## **REVISED STAFF REPORT AND RECOMMENDATION TO THE DESIGN COMMISSION**

CASE FILE: LU 20-102914 DZM AD GW (previously 19-225732 DZM GW)  
PC # 19-225732

***Alamo Manhattan Blocks***

# BLOCK 45A - WEST ELEVATION

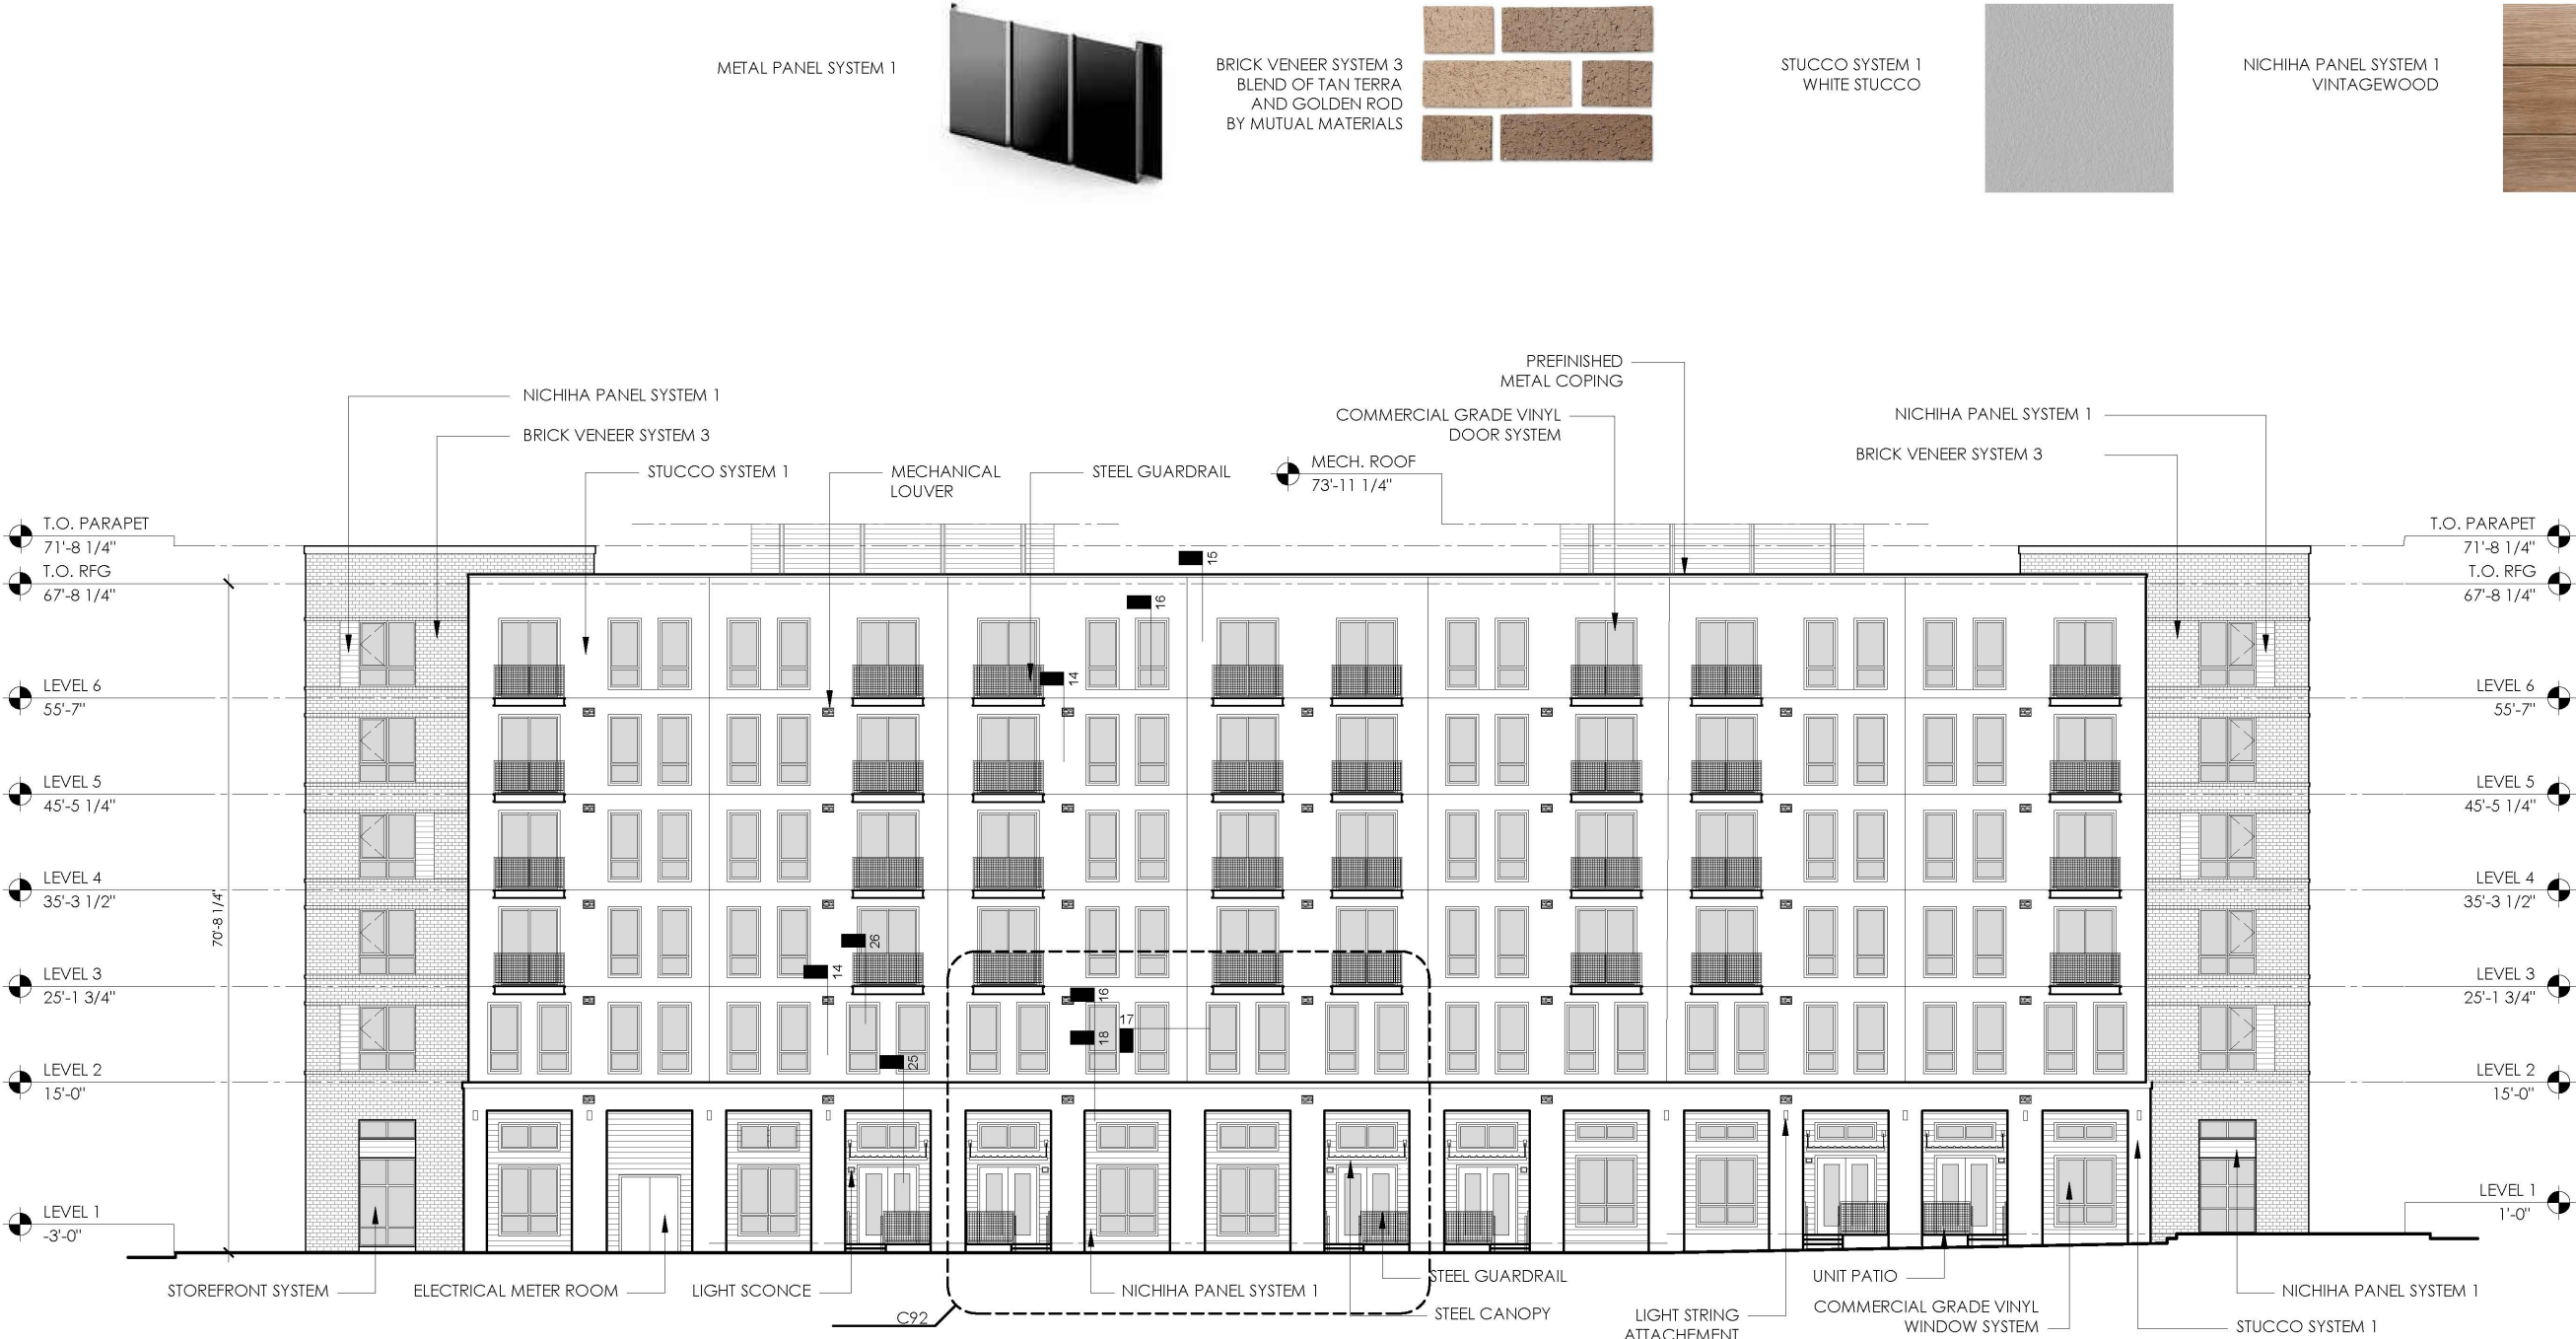
Block 45 (north building) - At the 12/12/19 hearing, the Commission expressed the need for deeper planar shifts and to work on the composition within these facades, more of the structure needed at the base to “ground” the building and provide texture and scale, and to revisit the number of materials and building details (canopies, brick detail, corner elements, solar shades, entries). Revisions have been made to address a lot of these concerns that result in a more coherent composition. Punched windows provide articulation in the façade, as do Juliette balconies on the south elevation. The window to wall ratio in the recessed facades and their ground level has been recalibrated. However, Staff has the following comments:

- The Commission recommended a low stem wall at the storefronts as the glazing to the ground was not working. Low curbs have been added in a few places to address grade changes, however, a more generous and consistent stem wall would be a more appropriate response to the Commission's comment.

- Similar to Block 42, Louvers/exhaust for the ground floor units and garage need to be identified and a section provided.
- Railing detail for the Juliette balcony is needed.

# BLOCK 45B - SOUTH ELEVATION

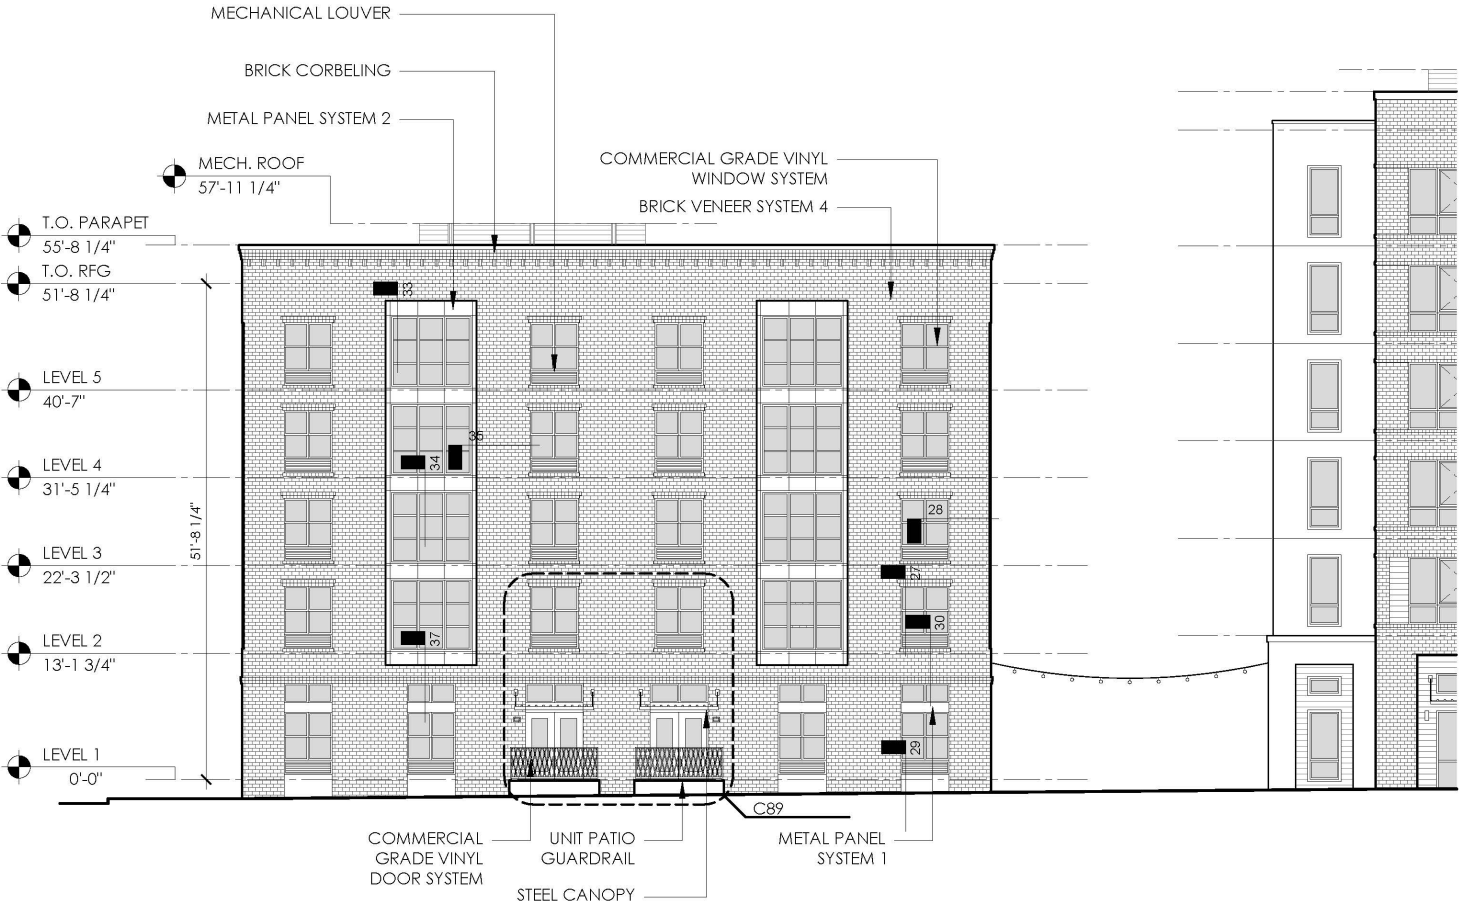
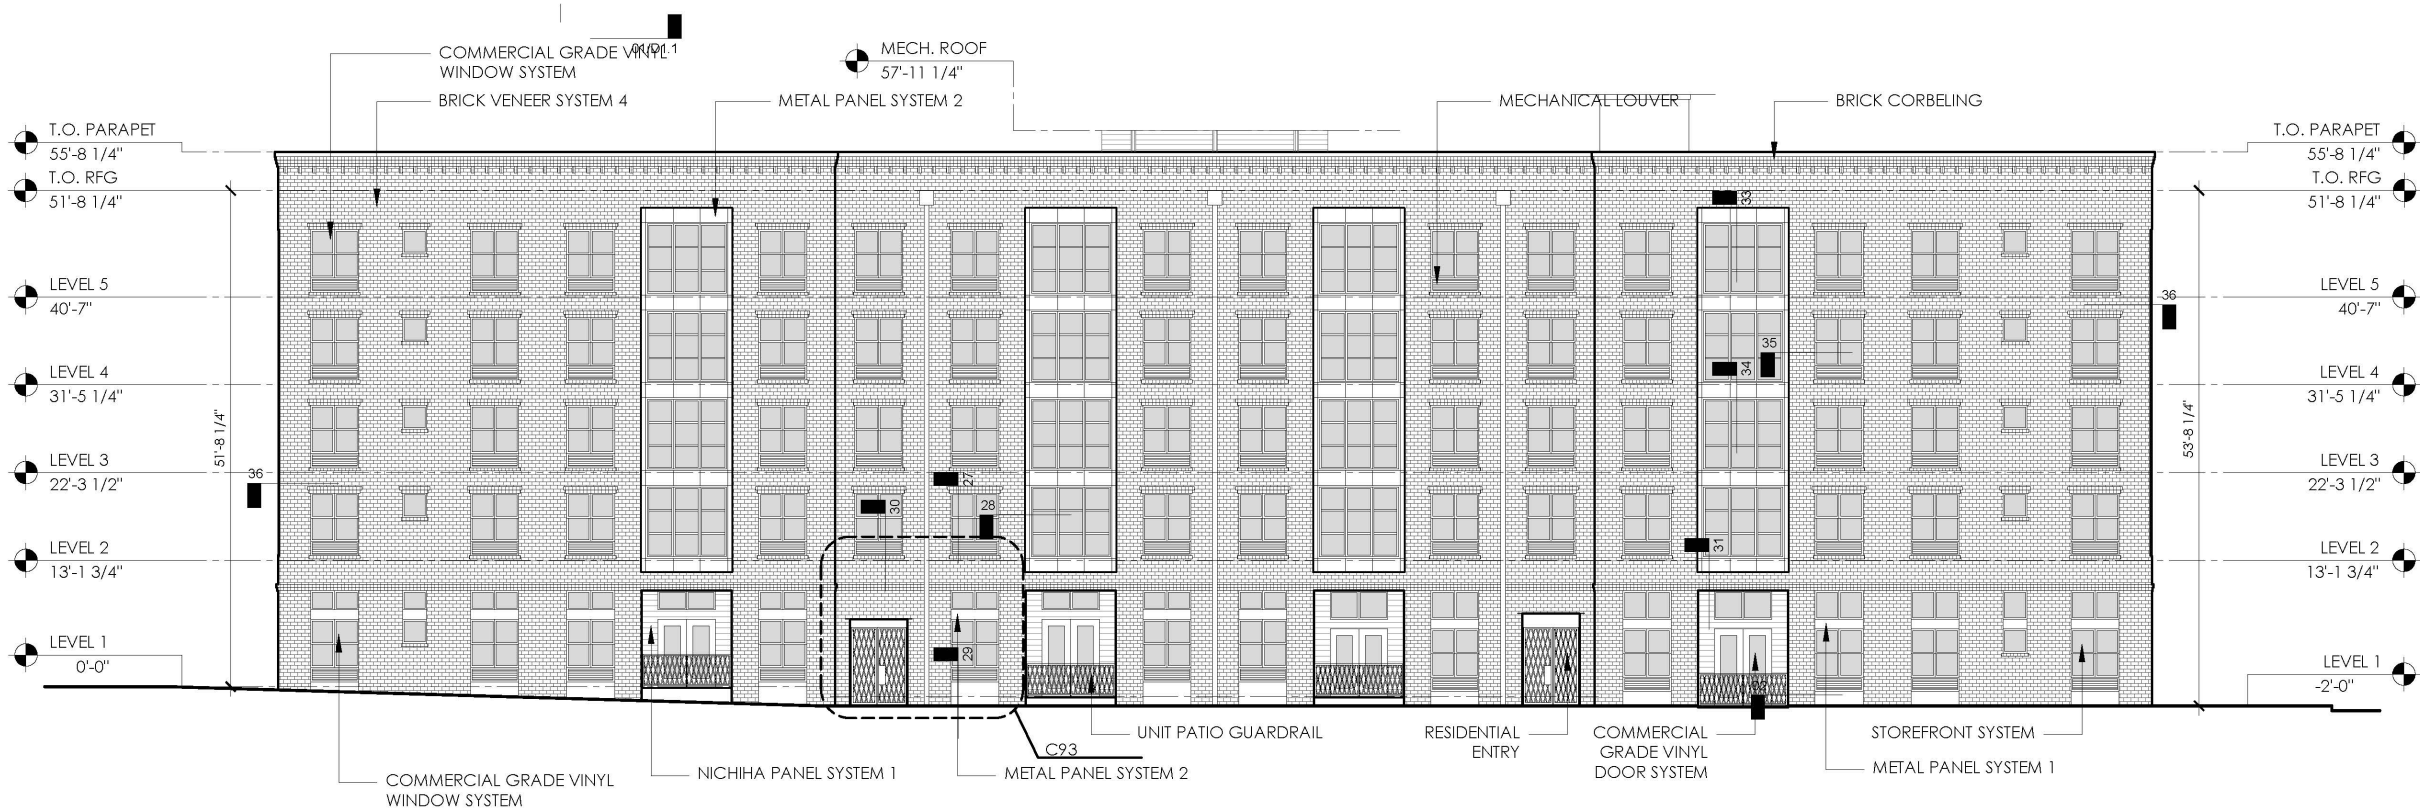
Block 45 (south building) – At the 12/12/19 hearing the Commission was split on the gabled roof and concerned with detailing as the roof transitioned into a wall cladding. The design concept has been overhauled for a more typical brick, flat roof building. Overall, the composition is straight-forward, the punched windows in the brick provide articulation and the louvers are integrated into the windows. However, staff notes the following:

- The design and brick detailing are more traditional than that found in the district. It feels more akin to buildings in Northwest. However, the metal clad bays do add a contemporary element, that could spur more modern details for a coherent and contextual composition.

- For a stronger composition, brick should return the entire length of the wall where inset balconies occur. Accent material could be applied to the back wall, similar to what the plan detail shows for the main entry condition on Bond.
